## #6.2.2.3.7 Image Quality : current status on diffuse sky-light exposure

# OICA proposal for dual function systems

# Dual function mirror+monitor

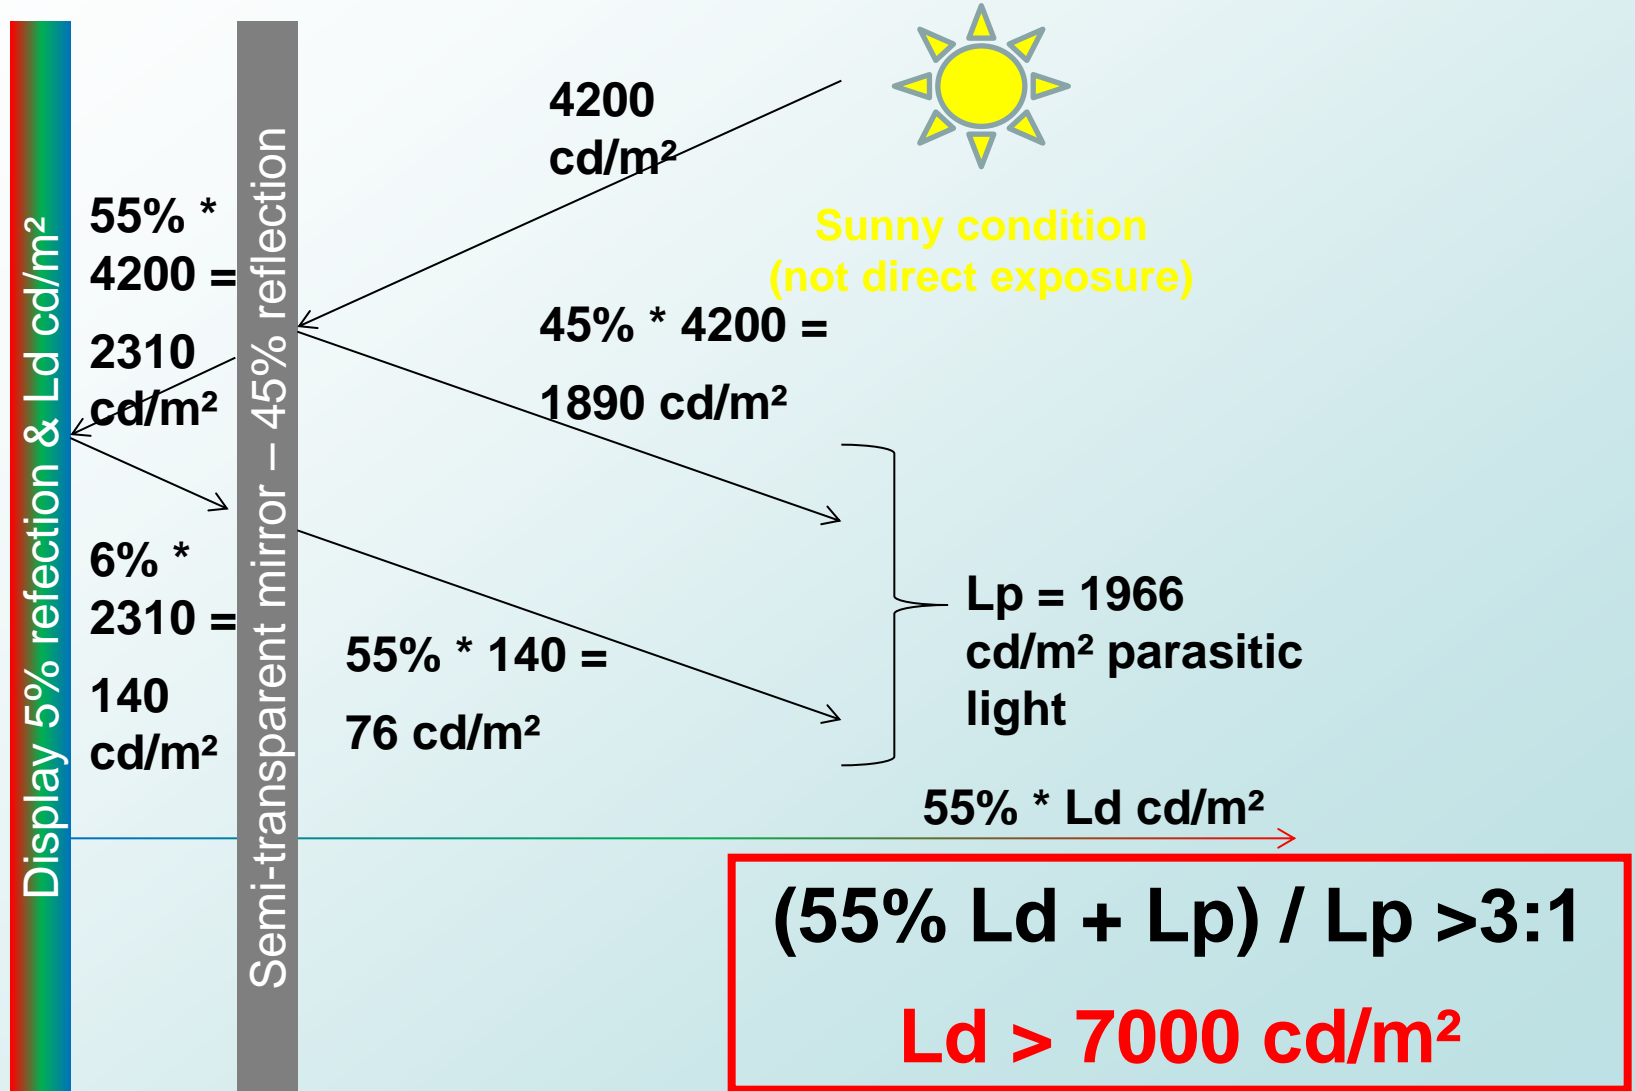
- Considering that
  - This function allows a very soft transition for drivers to switch from current technology to CMS
  - The mirror being always available for the driver
  - The system is orientable to all driver morphology
- Request test exemption for these functions
